Model type:
ASL60VEX

Commercial code:
F030651

1270110 Exploded views

N1040391FIG1

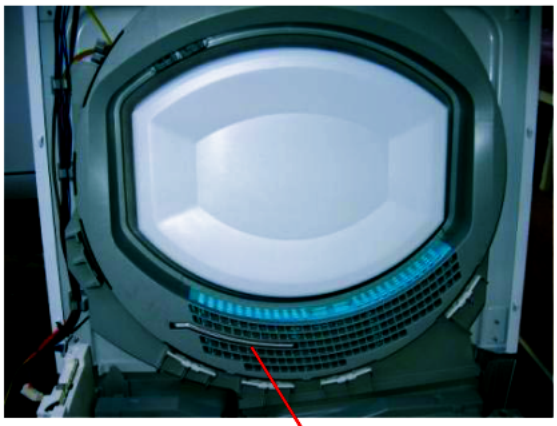
n1040391: Sensor, heating element and thermostat modified on vented dryers.

From serial no. 50712.0001, the following parts have been introduced progressively on vented dryers:
- new sensor (figure N1040391FIG1);
- new heating element;
- new thermostat.

New parts:
C00141612 - sensor strip - (ref.257)
C00145650 - drum - (ref.422)
C00141607 - drum support (there are 2 on all dryers) - (ref.463)
C00142301 - heating element - (ref.430)
C00142300 - thermostat kit - (ref.432)

premodification parts:
C00145759 - drum - (ref.422)
C00112186 - drum support - (ref.463)
C00113836 - sensor brush bracket - (ref.468)
C00113838 - insulating material for sensor strip - (ref.469)
C00113837 - sensor strip - (ref.469)
C00113817 - sensor brush - (ref.470)
C00113816 - brush bracket - (ref.470)
C00116602 - heating element - (ref.430)
C00112196 - thermostat kit- (ref.432)

The eeprom and circuit diagram were also affected by the modification (Figure N1040391FIG2).

The new items are not interchangeable with the premodification ones.

The replacement eeprom codes and relevant serial number are listed below.
new C00119913 - premodification C00114818 - s/n 50712.0001 - cc 30651 - ASL60VEX
new C00142176 - premodification C00114812 - s/n 50712.0001 - cc 33618 - ALE60VFR
new C00119916 - premodification C00115197 - s/n 50714.0001 - cc 30638 - ISL60VEX
new C00142177 - premodification C00114819 - s/n 50802.0001 - cc 30636 - ISL60NL

N1040405FIG1

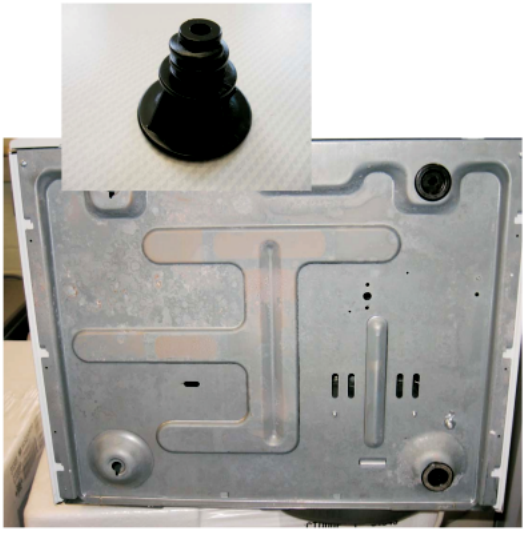
n1040405: Feet installed on dryers

Four feet have been installed on the dryers referred to in this release (see pictures N1040405FIG1-FIG2).

New parts
C00142439 - foot
C00142908 - base

premodification parts
C00095591 - wheel
C00095592 - pivot
C00112148 - base

N1040411FIG1

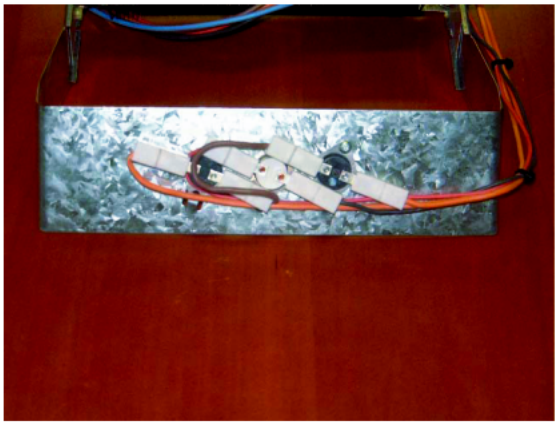
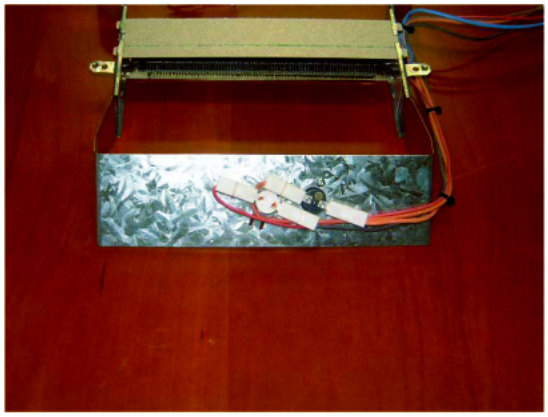
n1040412: Modifications of heating elements/thermostats on venting dryers.

1) All appliances with serial number prior to 50712.0001 are equipped with a heating element assembly with the following thermostats:
a) one-shot
b) cycling
c) ntc

2) From serial no. 50712.0001 the cycling thermostat has been eliminated, the heating element assembly is composed of the following thermostats:
a) one-shot
b) ntc

C00142301 - heating element assembly (with one-shot + cycling + ntc sensor)
C00116812 - heating element assembly (with one-shot + cycling + ntc sensor) for SK dryers
C00112196 - thermostat kit (one-shot + cycling)
When replacing the thermostats on models with serial numbers subsequent to 50712.0001 order the assembled heating element.

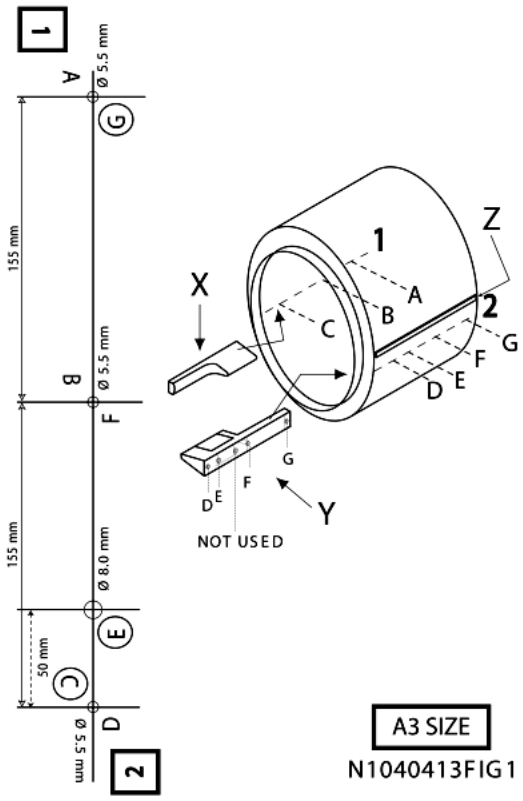
n1040413: Intervention for replacement dryers drum.

Hereunder there are all information to fit the drum C00145759 in the following models:

1)remove from the dryer in assistance these parts:
-original lifters (X – Y) fitted inside the drum;
-sensing band and insulation band;

2)fit again the two original lifters (X – Y) inside the drum C00145759 drilling 3 holes C-G-E highlighted in the relevant drawing

a-LIFTER X - fits in opposite side of the drum to the drum seam (Z):
with drawing position 1:
5.5mm hole at position C;
must be free from swarf and rough edges;
fit again the lifter X tightening all screws;

b-LIFTER Y - adjacent to the drum seam (Z):
with drawing position 2:
5.5mm hole at position G and 8.0mm hole at position E;
must be free from swarf and rough edges;
fit again the lifter Y tightening all screws except E screw;
fit again outside the drum the sensing band and insulation band;
tight the E screw;

3)it is important to check that the complete insulation is maintained between the metal sensor in the lifter Y and the metal surface of the drum;

4)it is essential to verify the electrical conduction between the metal sensor in the lifter Y and the sensing band.
